# Access Compliance Report

## Public Rights-of-Way

### (Curb Ramps)

Intersection ID: N/A	Main Street: GREEN_REA_RD	Cross Street: OCKLEY_MANOR_LN	Location: SW
ADA ID: 977DE01E5B4A	Ramp Type: PerpDiag	Initial Pass/Fail: Fail	Overall Compliance: No
Codes/Mitigation Info/Possible Solution		Field Measurements/Component Compliance

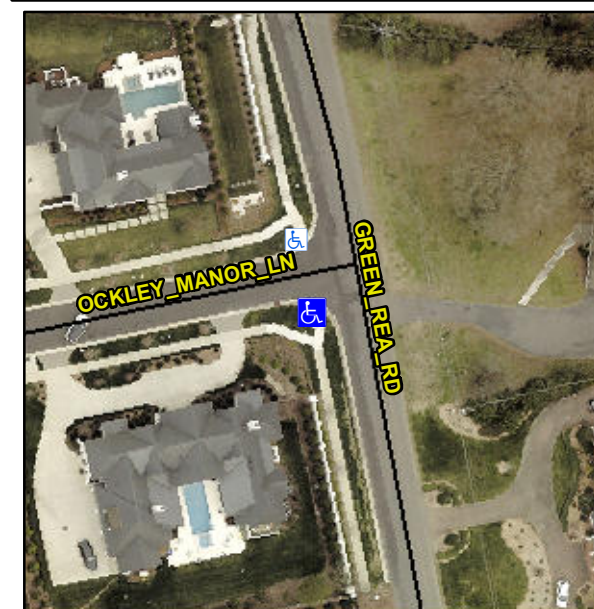
**Not Found, R304.2.2, R304.5.3**

Compliance	Description	Data	Compliance	Description	Data
N/A	Ramp Length (in)	84.0	No	Ramp Slope (%)	9.0
Yes	Ramp Width (in)	62.0	No	Ramp XSlope (%)	4.2
N/A	Flare Type LT	N/A	N/A	Flare Type RT	N/A
N/A	Flare Slope LT (%)	N/A	N/A	Flare Slope RT (%)	N/A
N/A	Flare Traversable LT?	N/A	N/A	Flare Traversable RT?	N/A
N/A	Landing Length (in)	N/A	N/A	DWS Provided?	N/A
N/A	Landing Width (in)	N/A	N/A	DWS Contrast?	N/A
N/A	Landing Slope (%)	N/A	N/A	DWS Length (in)	N/A
N/A	Landing X Slope (%)	N/A	N/A	DWS Full Width?	N/A
N/A	Landing Curb? (Y/N)	N/A	N/A	DWS Offset (in)	N/A
N/A	Shared Landing?	N/A			
N/A	Gutter Ponding?	N/A	N/A	Gutter Slope (%)	N/A
N/A	Gutter Lip Ht (in)	1.5	N/A	Gutter X Slope (%)	N/A
N/A	Painted X Walk1?	No	N/A	Painted X Walk2?	No
	X Walk 1 Direction	To E		X Walk 2 Direction	To N
N/A	X Walk 1 Width (in)	N/A	N/A	X Walk 2 Width (in)	N/A
	X Walk 1 Slope (%)	1.5		X Walk 2 Slope (%)	1.1
	X Walk 1 X Slope (%)	0.5		X Walk 2 X Slope (%)	1.8

**Remove & Replace Curb Ramp With Two New Directional Ramps or Equivalent.**
